1050 Acacia, Montara

Building Height Calculation
 Revised 9/24/07 Prepared by: RC

EXHIBIT H-2
 (rev 4)

A6.2
 partial

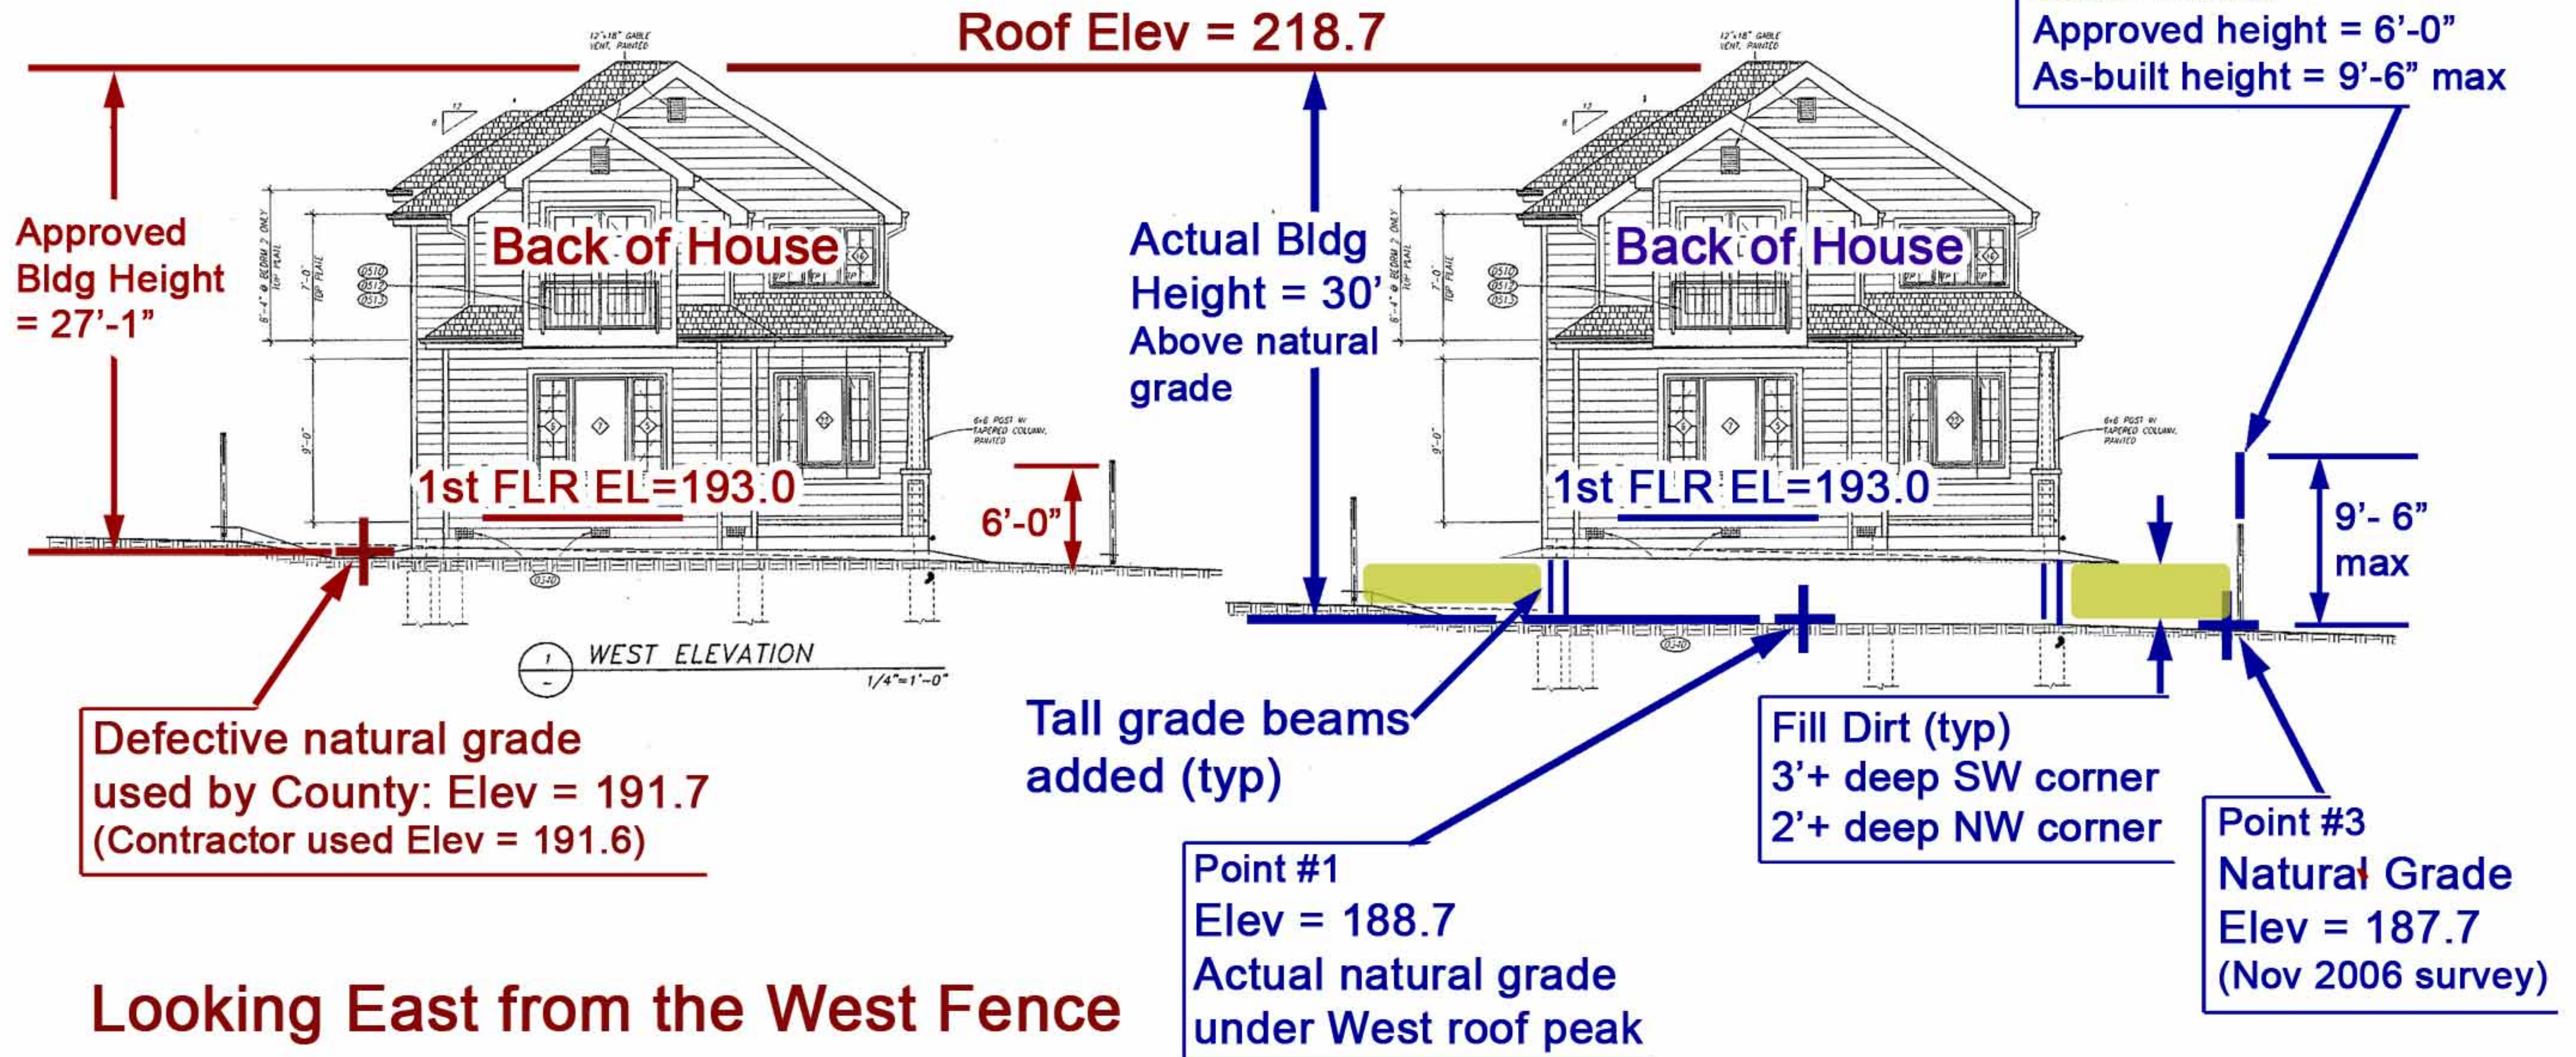
Plans approved by the CDRC in Nov 2005 show the following: 1) The ground elevations much higher than actual - the error is up to about 3' at the west end of the property (i.e. the contours on the submitted plans were defective). 2) The 1st floor about 2' above the ground on the west end of the house. 3) No fill dirt around the house except for a few inches around the foundation. 4) House height of 27'-1" (so 27'-1" is the approved maximum height above 'natural grade'). 5) A 6' high fence on the South side with no fill dirt next to the fence.

Due to the defective elevations used on the design plans the as-built 1st floor is about five feet above the actual original ground at the West end (not the approximate 2' shown on approved plans). To compensate for the actual ground level being lower than shown on the plans, the contractor built tall grade beams (foundation walls) and placed deep fill dirt around the foundation walls; depth of dirt fill is about 3' at the Southwest corner of the house.

The actual house height of approximately 30' (above natural grade) violates the max allowable height of 28' under Zoning Regulation 6300.2.6. The dirt fill violates Zoning Regulation 6300.2.6 and Grading Ordinance 8602. The as-built fence on the South boundary reaches a max height of 9'-6" - a violation of Zoning Regulation 6412 (max allowable fence height = 6'-0").
